ADDENDUM NO. 2

DATE: **November 20, 2026**
FROM: **City of Grand Junction Purchasing Division**
TO: **All Offerors**
RE: **2026 Waterline Replacement Project IFB-5998-26-DD**

CITY OF GRAND JUNCTION
2026 WATER MAIN IMPROVEMENTS
LAGUNA DR TO ZUNI DR WATER LINE
PLAN & PROFILE

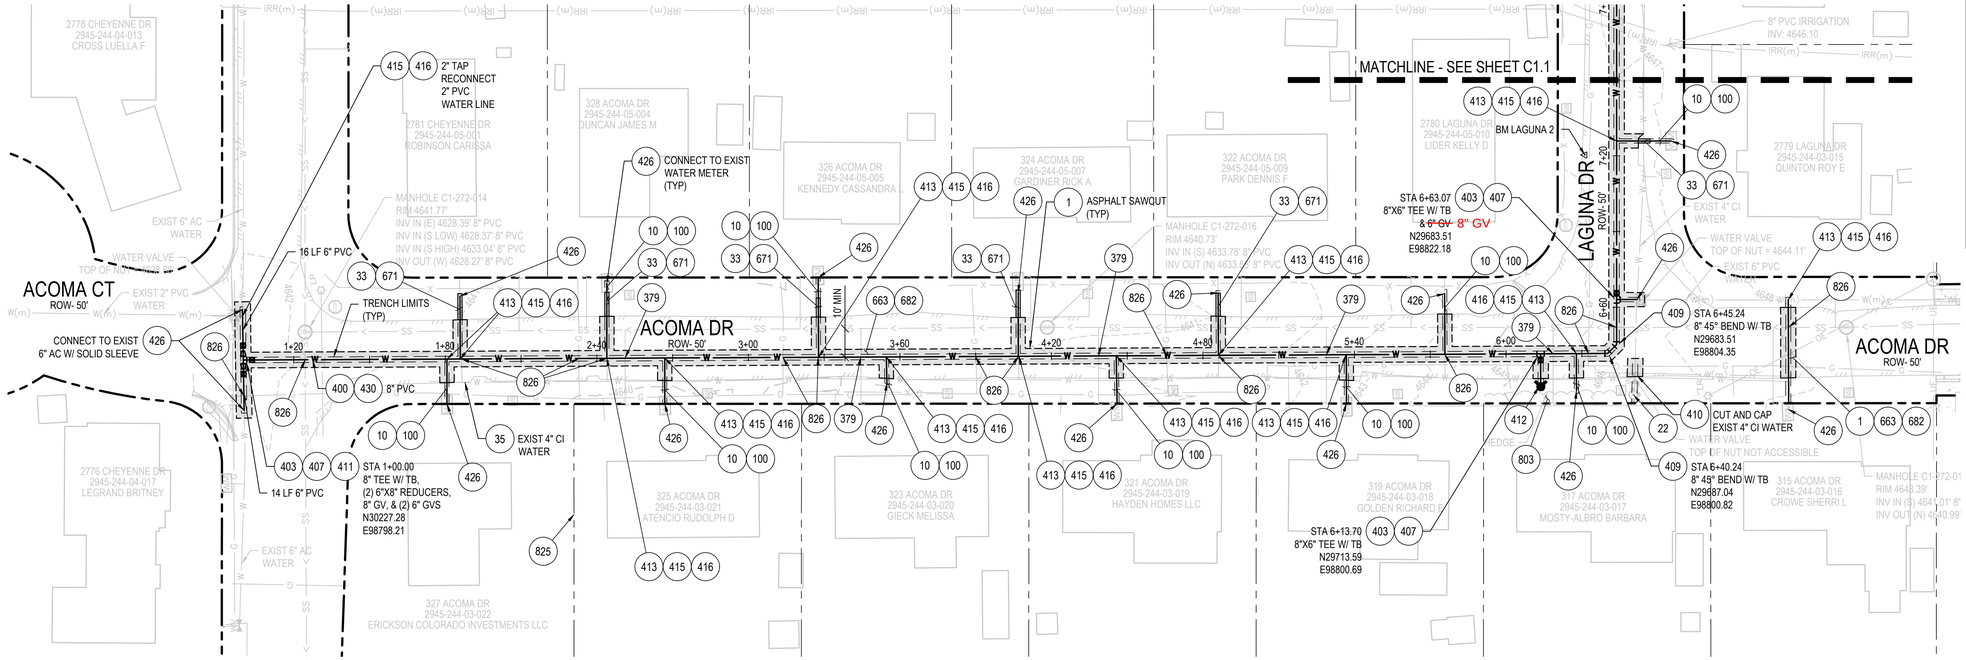
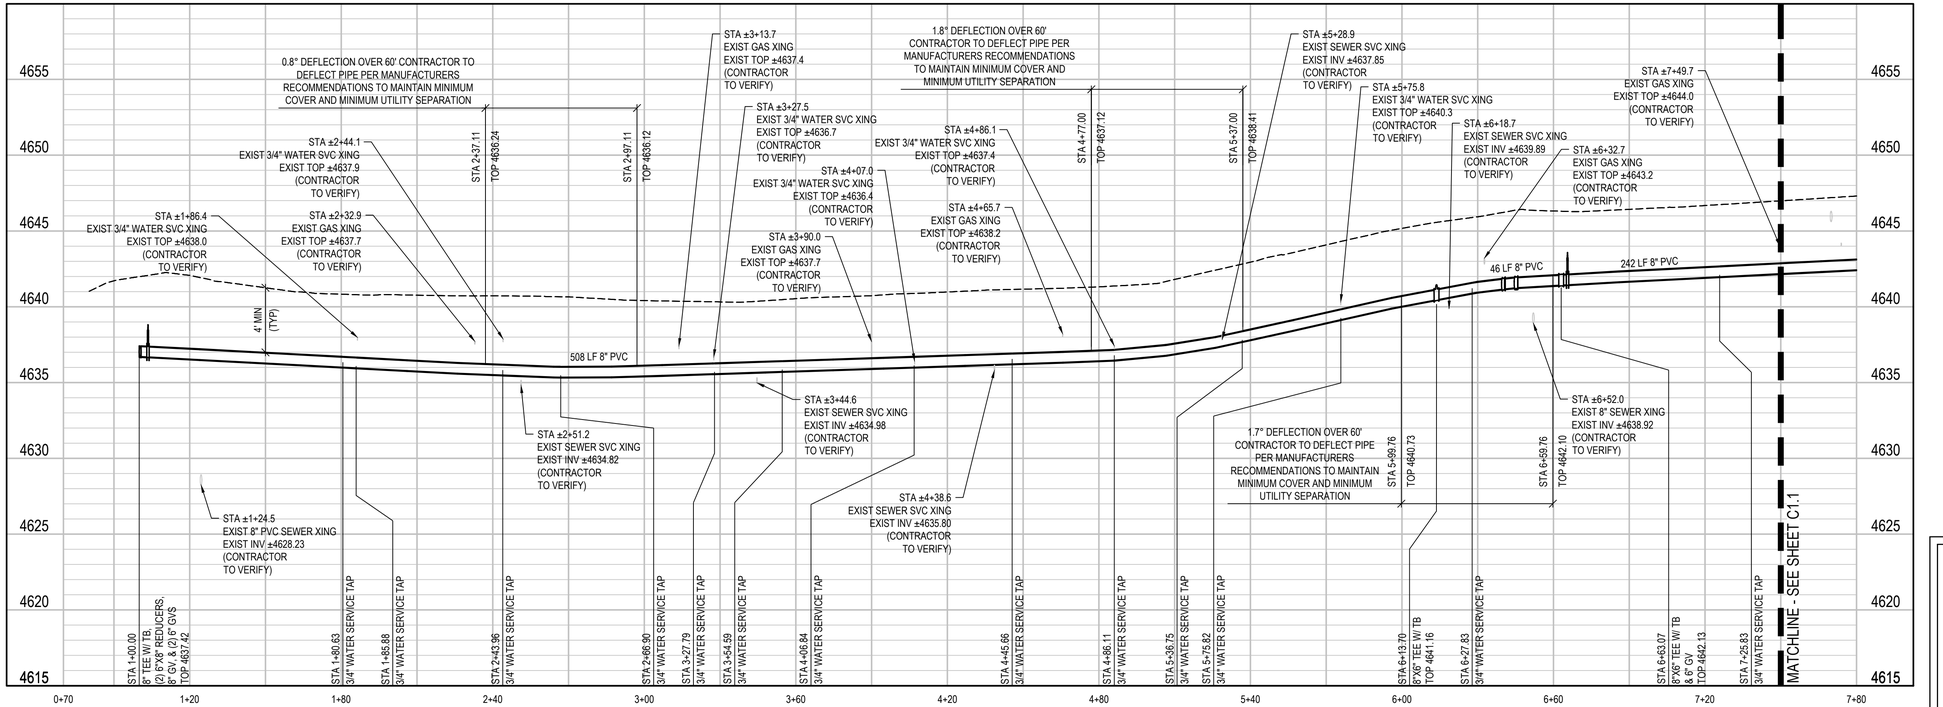
16. **Question:** Would it be possible to clarify the type of tunnel required/approved for the trenchless installation? Is there associated specification sections that go along with it?

Answer: The Contractor shall select a suitable trenchless method and any necessary casing and joint restraints. The completed water main shall be 8-inch C900 PVC, DR18 or thicker wall, meeting the alignment, elevation, and other requirements shown on the drawings. See PSP-3 for trenchless installation and work-plan requirements. The Contractor remains responsible for its means, methods, and installation design. All associated costs are included in Bid Item 4.

C1.0

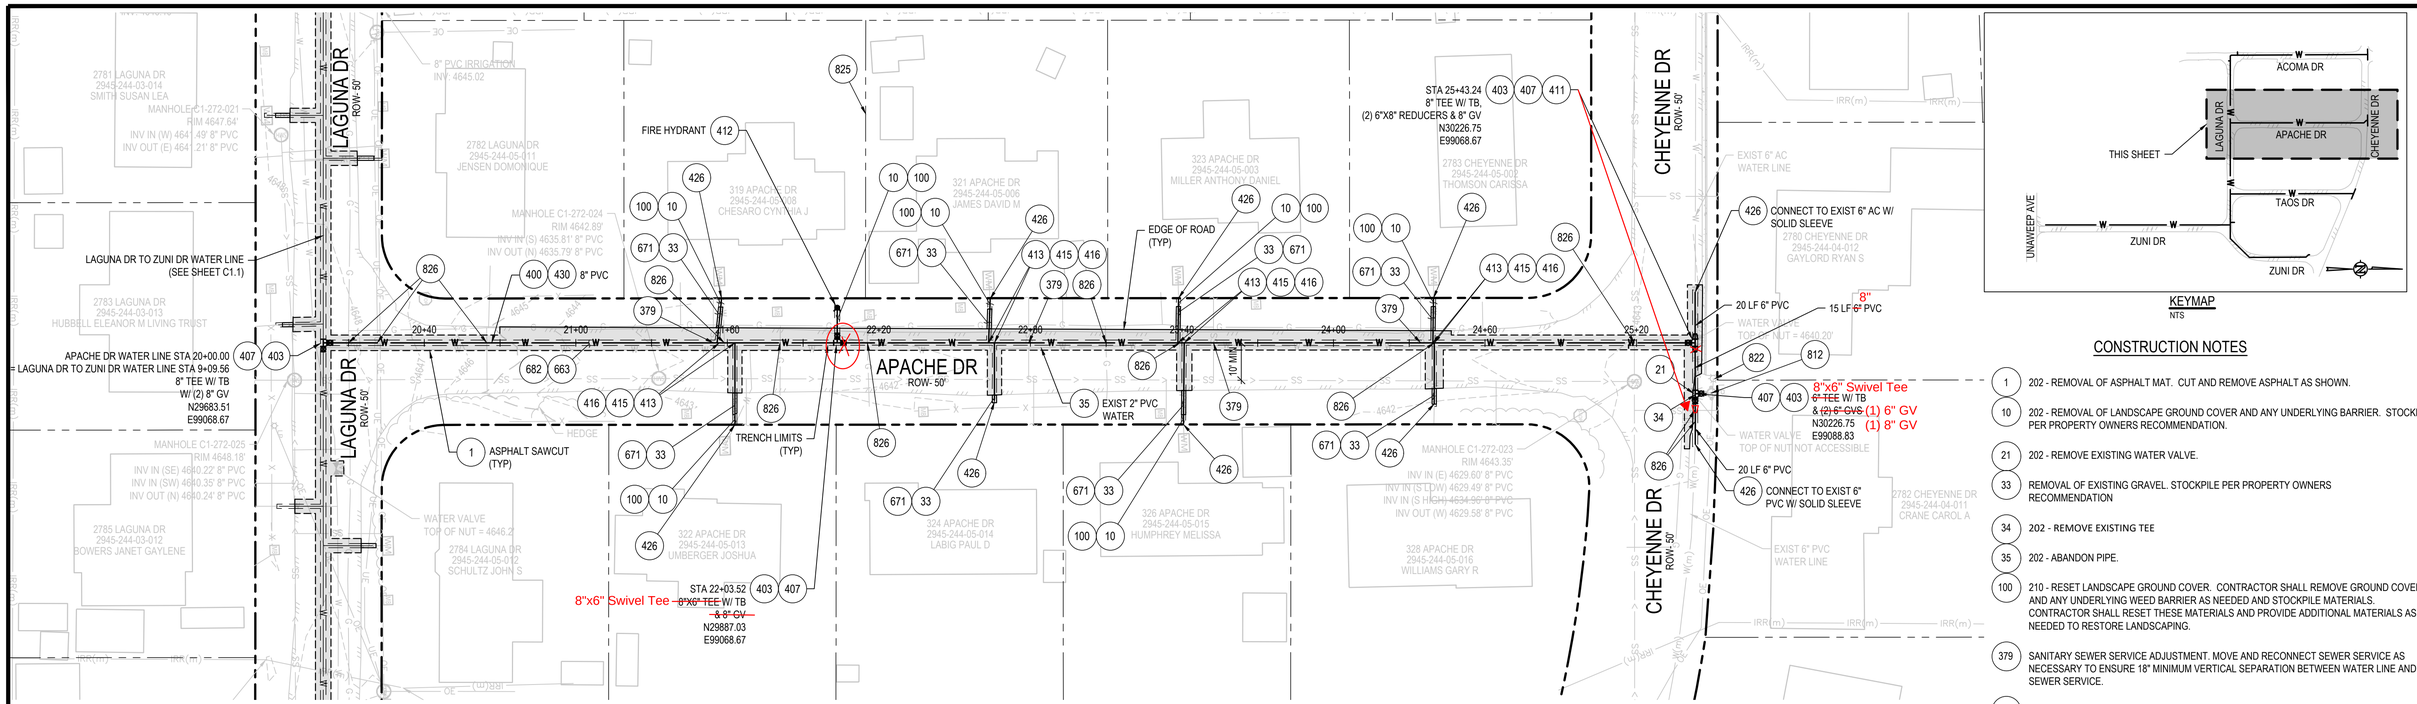
2. **Requesting Clarification on the following items:**
   - **Bid item #10 8" GV- bid shows 16, plans have 14.**
     The quantity remains 16. The 8" GV at STA 22+03.52 on Apache Dr will be omitted. The 6" GV at STA 6+63.07 should be an 8" GV. The 6" GV on the main line in Cheyenne at STA 25+43.24, east of the replacement fire hydrant, should be an 8"GV with the reducer east of that. Please refer to the red notes on the attached drawings. The (16) 8" GV's are located at STA 1+00.00, 6+63.07, 9+09.56, 11+88.20, 13+13.46, 20+00.00, (2) @ 25+43.24, (3) @ 34+89.28, 30+00.00, 40+00.00, 47+33.03, 100+43.88, and 103+65.57.

5. **Question:** On sheet C1.0 to the south of the intersection of Laguna Drive and Acoma Drive, what size is the water service line? Looks like it comes off a 6’’ Water Line based upon the tee install at Sta. 6+63.07? And then is it a 2’’ or ¾’’ service line?
   Answer: : The City’s records indicate that water service is a 3/4". Bid item #65 for a 6”x3/4” tapping saddle has been added.

C2.0

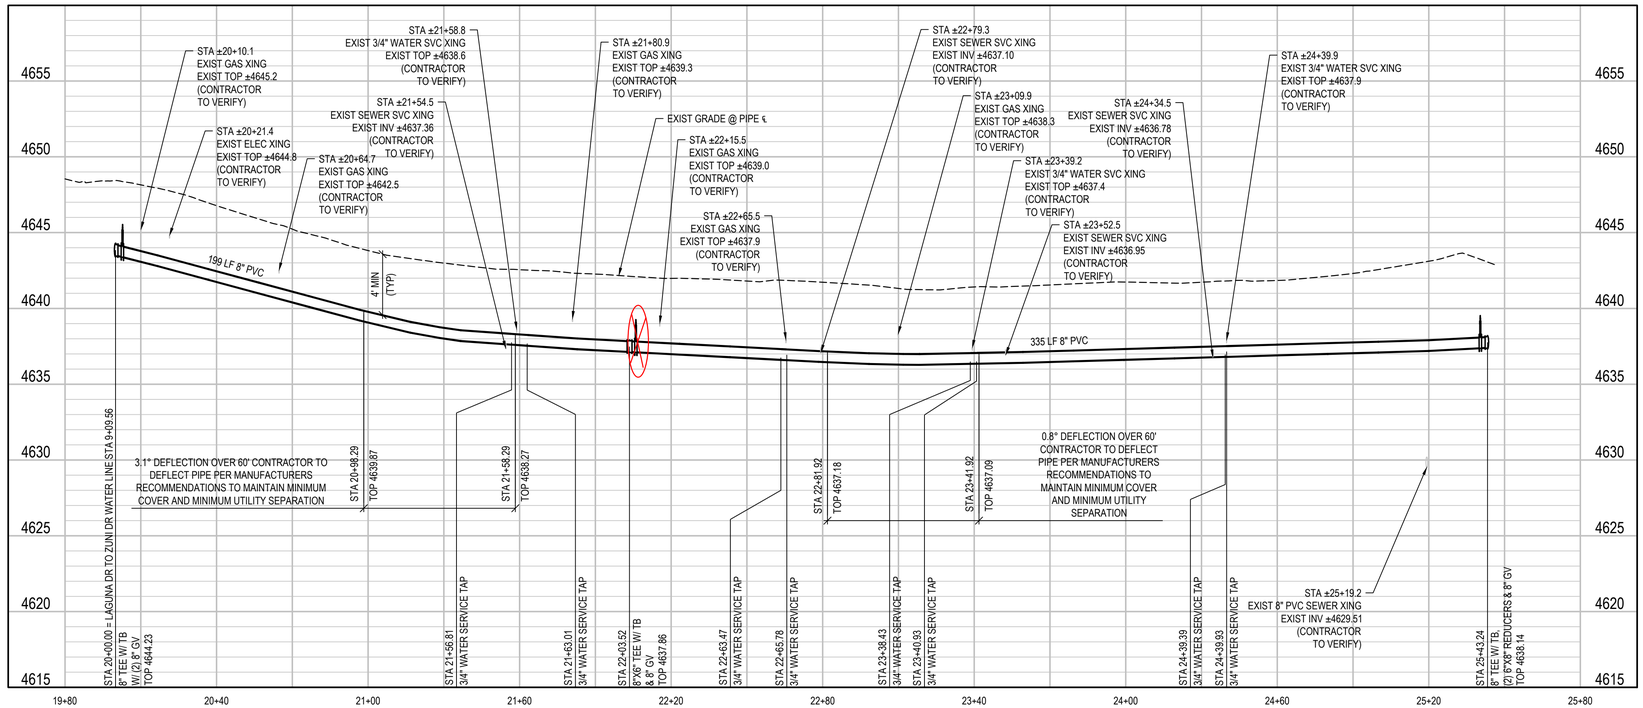
6. **Question:** On C2.0, 2’’ PVC abandonment is called out with Note 35, but there is no SOV item for it. Please clarify where to include this cost.
   Answer: Abandonment of the existing 2” PVC waterline is incidental to Bid Item 3, 8-inch Water Pipe, consistent with the general clarification regarding existing pipe abandonment. No separate bid item will be added.
